Access Compliance Report

Public Rights-of-Way

Intersection ID: 50584	Main Street: GREAT_LAUREL_RD	Cross Street: GRAND_FIR_RD	Location: W
ADA ID: 2021A3E1BB8B	Ramp Type: Perp	Initial Pass/Fail: Fail	Overall Compliance: No
Severity Score: 10			
Codes/Mitigation Info/Possible Solution		Field Measurements/Component Compliance

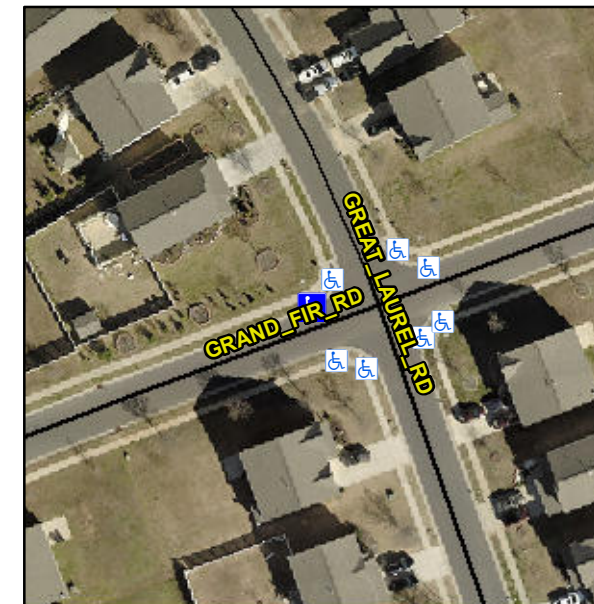
Not Found, R304.5.1, R304.5.3

Compliance	Description	Data	Compliance	Description	Data
N/A	Ramp Length (in)	49.5	Yes	Ramp Slope (%)	6.8
No	Ramp Width (in)	47.0	No	Ramp XSlope (%)	2.6
N/A	Flare Type LT	N/A	N/A	Flare Type RT	N/A
N/A	Flare Slope LT (%)	N/A	N/A	Flare Slope RT (%)	N/A
N/A	Flare Traversable LT?	N/A	N/A	Flare Traversable RT?	N/A
N/A	Landing Length (in)	N/A	N/A	DWS Provided?	N/A
N/A	Landing Width (in)	N/A	N/A	DWS Contrast?	N/A
N/A	Landing Slope (%)	N/A	N/A	DWS Length (in)	N/A
N/A	Landing X Slope (%)	N/A	N/A	DWS Full Width?	N/A
N/A	Landing Curb? (Y/N)	N/A	N/A	DWS Offset (in)	N/A
N/A	Shared Landing?	N/A			
N/A	Gutter Ponding?	N/A	N/A	Gutter Slope (%)	N/A
N/A	Gutter Lip Ht (in)	N/A	N/A	Gutter X Slope (%)	N/A
N/A	Painted X Walk1?	No	N/A	Painted X Walk2?	N/A
	X Walk 1 Direction	To S		X Walk 2 Direction	N/A
N/A	X Walk 1 Width (in)	N/A	N/A	X Walk 2 Width (in)	N/A
	X Walk 1 Slope (%)	1.6		X Walk 2 Slope (%)	N/A
	X Walk 1 X Slope (%)	0.1		X Walk 2 X Slope (%)	N/A

Remove & Replace Entire Ramp.
